## K025433XS for Ford 1.2, 1.4 and 1.6 engines

GATES REFERENCE : | K025433XS

1F05

Fig. 1 Fig. 2

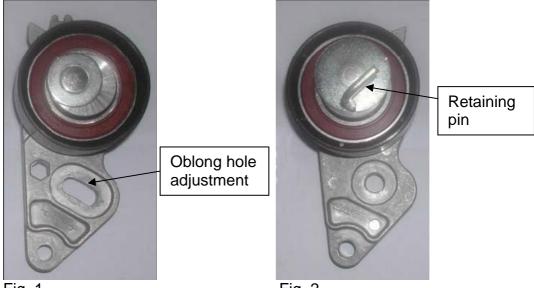
Over the last years the tensioner for the synchronous drive on Fiesta, Focus, Fusion, Puma and Mazda 121 with engines 1.2, 1.4 and 1.6 has changed a few times:

- different pulley diameter: 60 and 62 mm
- different appearance: with and without oblong hole

Now, Ford OEM and OES have replaced these tensioners by a new version (Ø 62 mm, OE nr 1361840/4M5G6K254DB, Fig. 2). As Gates is following the OE market, this new tensioner is now, since a few months, also included in our K025433XS, instead of the former type (Fig.1).

The new tensioner can replace all former types without problem. It is easier to install and avoids incorrect tensioning, as the back plate cannot be adjusted.

Install the new tensioner using the removed bolts (20 Nm), install the new belt 5433XS, pull the retaining pin out.

No other manipulating is needed, as the spring-loaded pulley will tension the belt correctly.
